Re: Chase Bank  
552 New Haven Avenue  
Derby, Connecticut

VHB is pleased to submit the following responses to the November 12, 2025, memo prepared by Ryan McEvoy from SLR International Corporations regarding the proposed Chase Bank on 552 New Haven Avenue:

# Truck Turn Exhibit - Fire Truck

## Proposed Chase Bank

# BULLET - MINI OUTDOOR RECESSED FIXED DOWNLIGHT

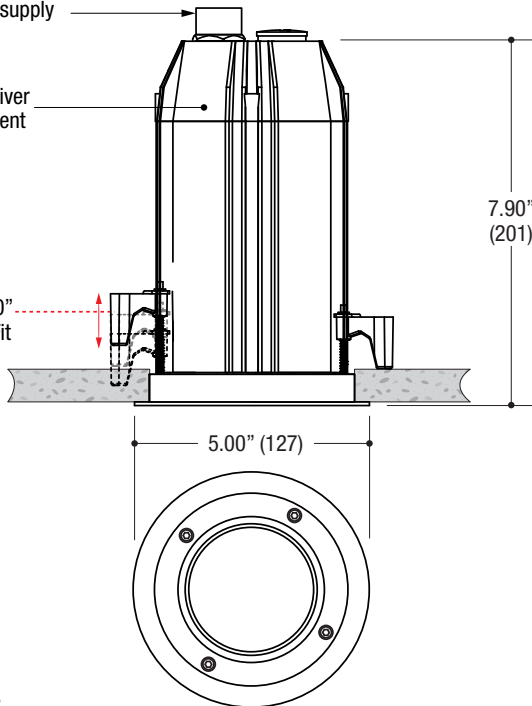
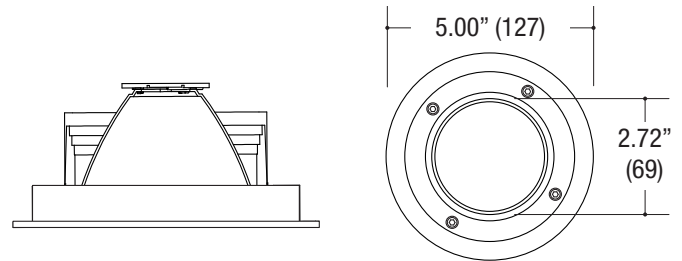
**Comment 5:** The plans include two site lighting poles at 20' height. No information, however, is provided regarding the light fixture chosen as a basis for the photometric analysis. Also, based on the photometric plan, there does not appear to be any building mounted lighting proposed. The applicant's engineer should confirm where building mounted lighting is proposed.

**Response:** The lighting plan proposed three new light poles using Evolve EACL Series fixtures that will be dark sky compliant. There are two exterior recessed lights proposed over the main entrance canopy. Details & specifications for both fixtures have been attached to this letter.

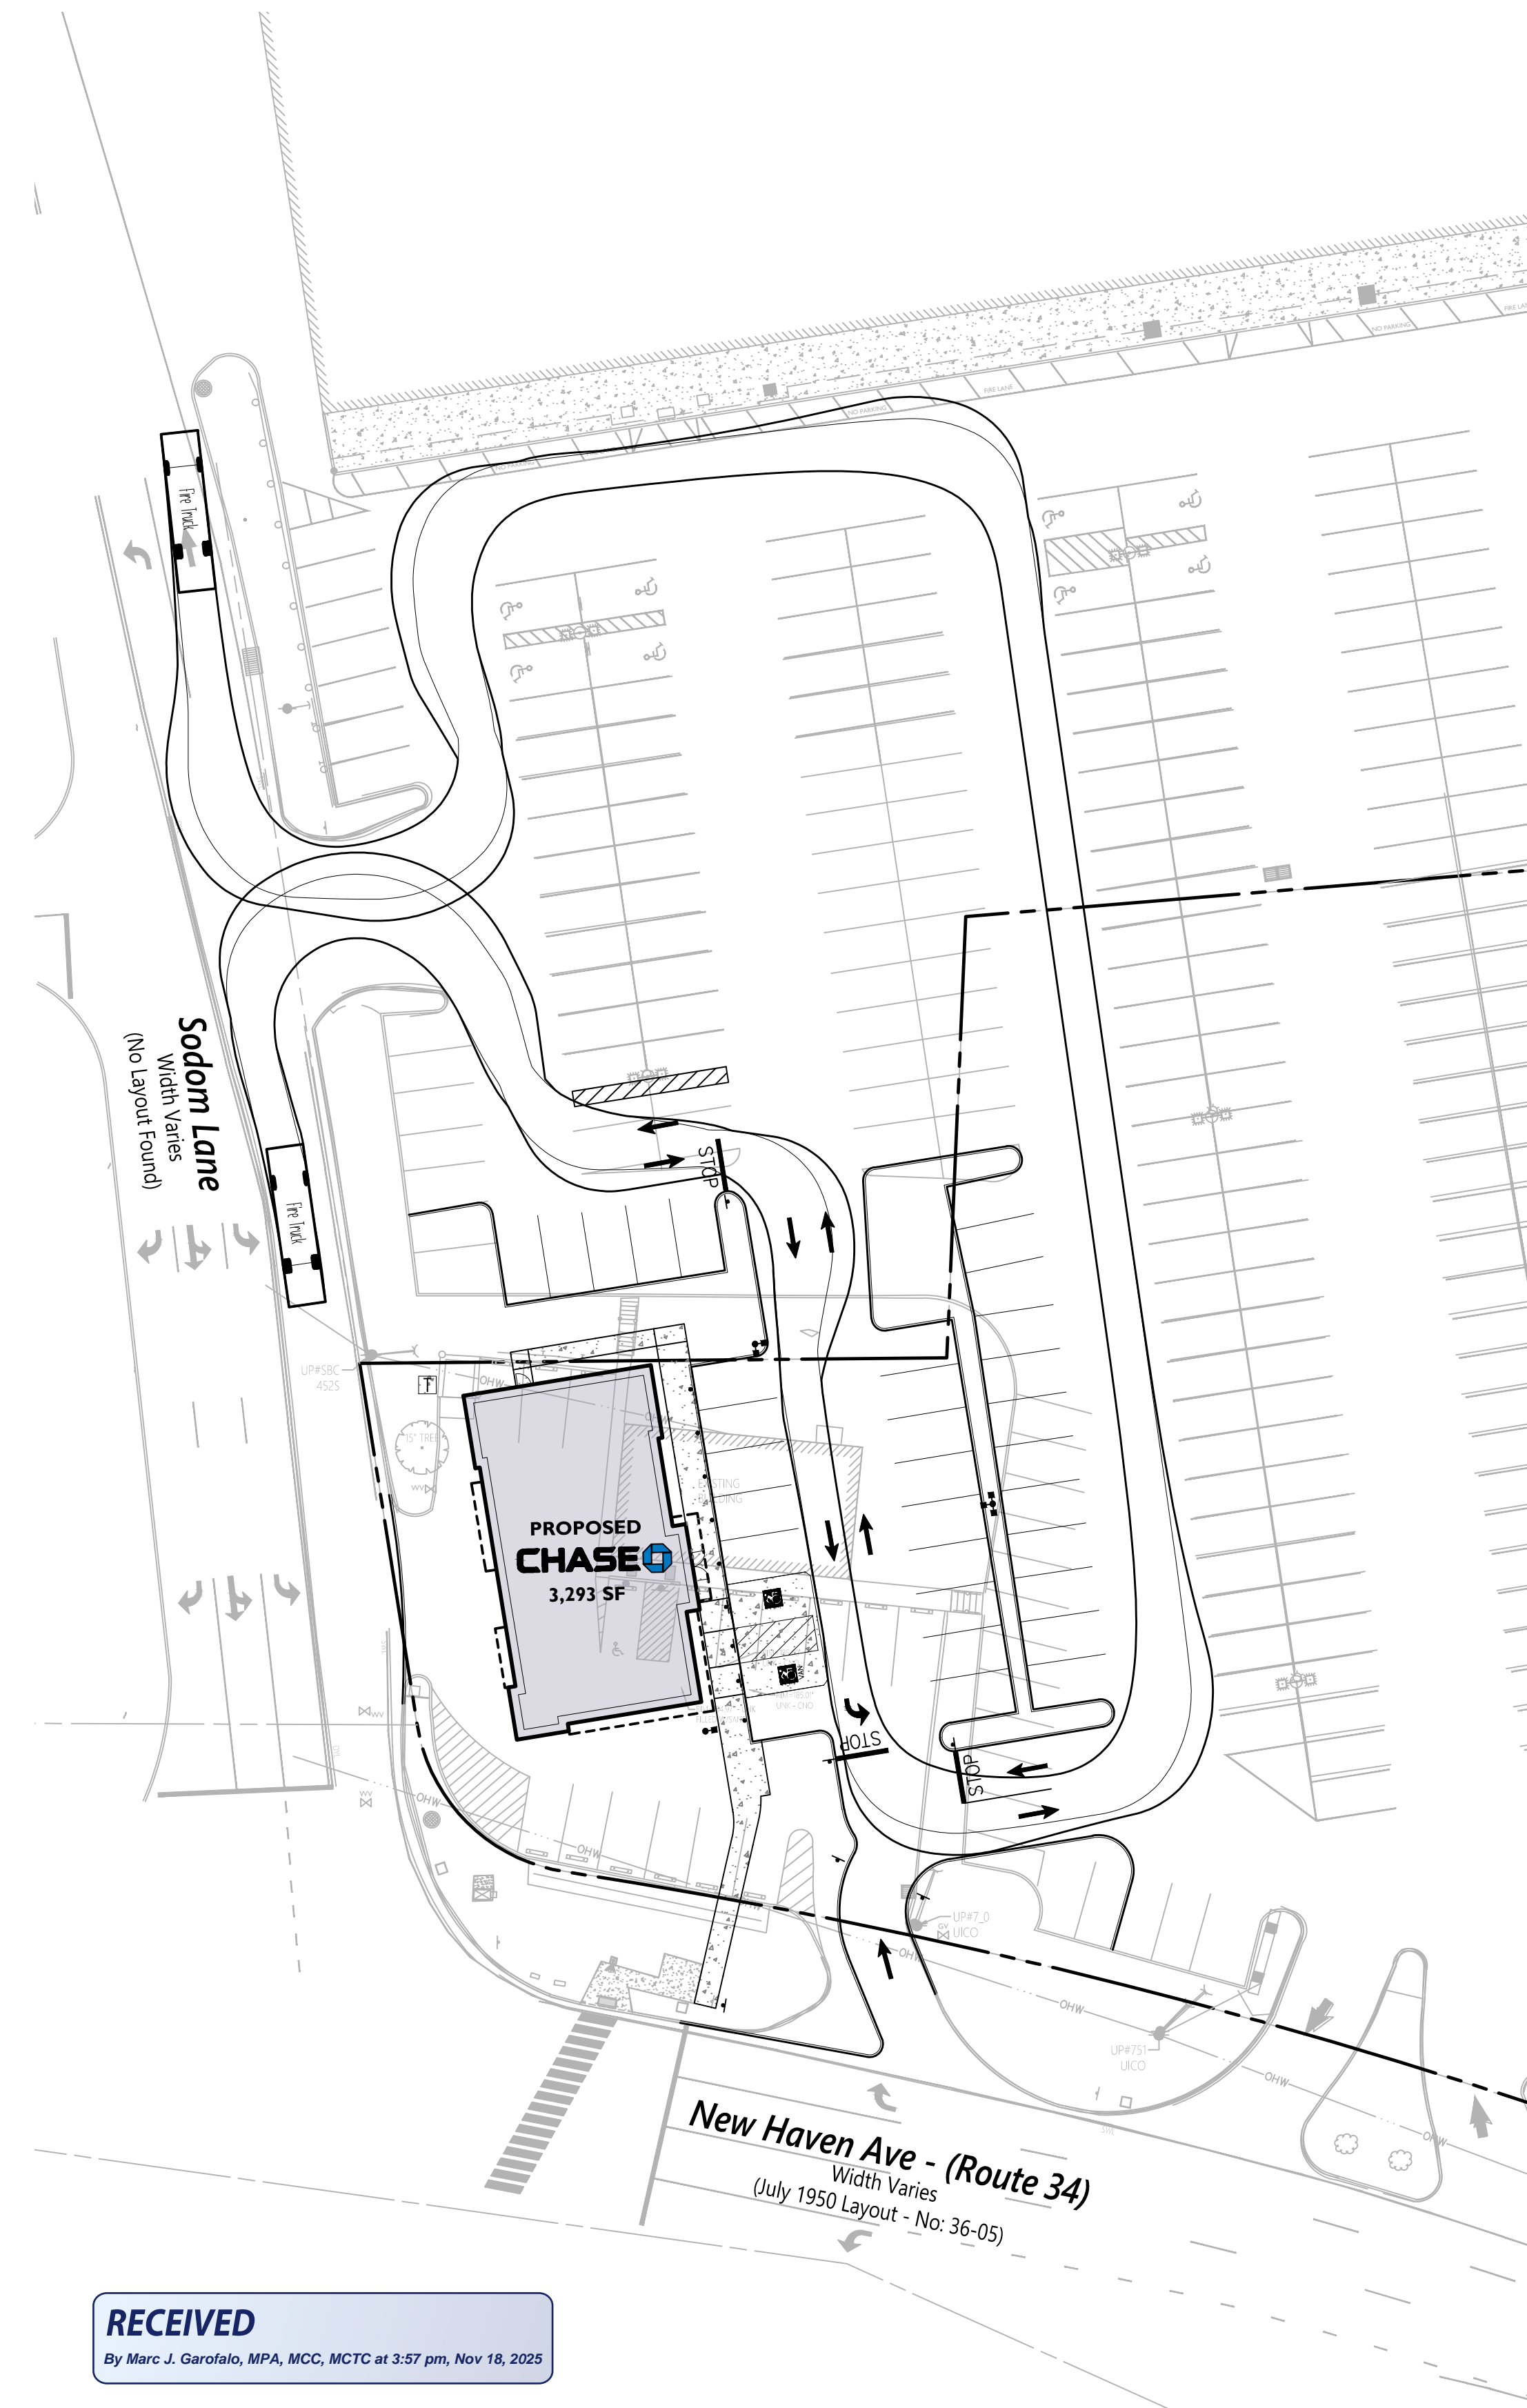
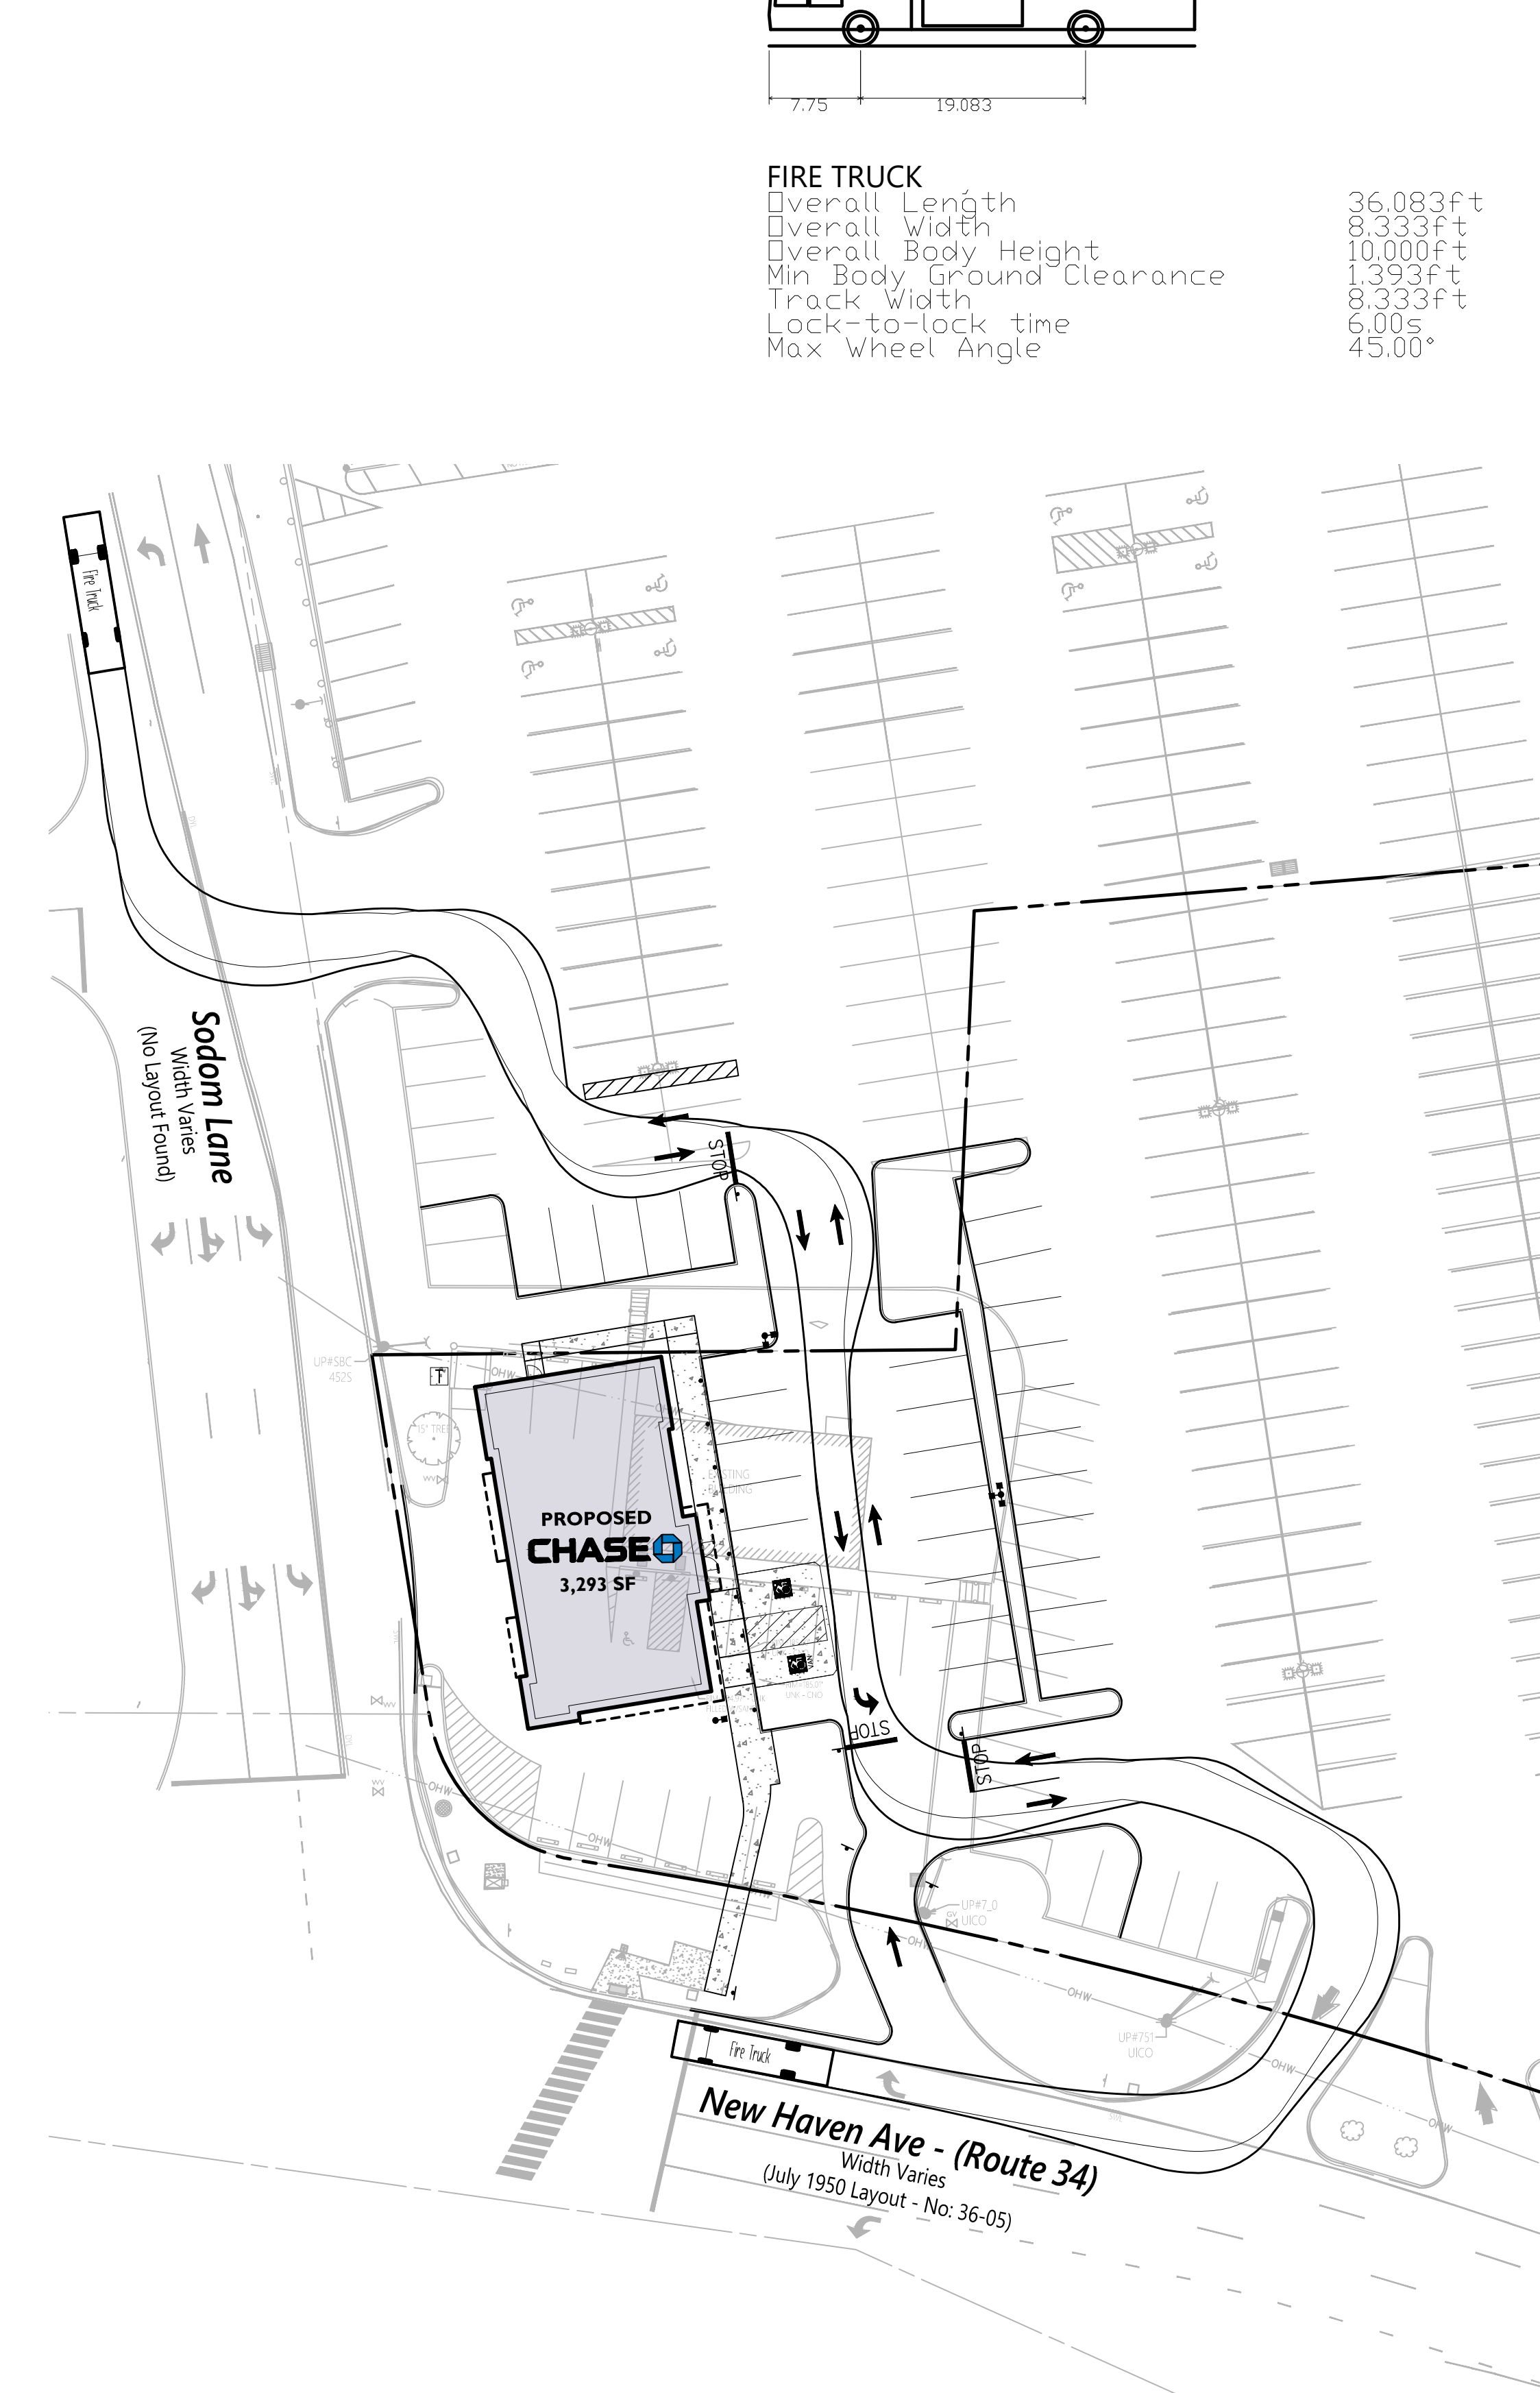
- c. Consideration should be given to slightly modifying the one way entrance off New Haven Avenue to better align with the proposed parking spaces adjacent to the Chase Bank. Note that this would require shifting of an existing utility pole.
- d. Emergency vehicle access to the Chase Bank site should be reviewed with the Fire Marshall's Office.

- c. The suggested modification for the right-in only entrance off of New Haven Avenue will be considered and reviewed with CTDOT.
  - d. Emergency access has been reviewed with the Fire Marshal and Fire Chief. Vehicles turning templates using a comparable fire apparatus have been provided for the Fire Marshal's and Fire Chief's review. The turning movements have been attached to this letter in support of the application.
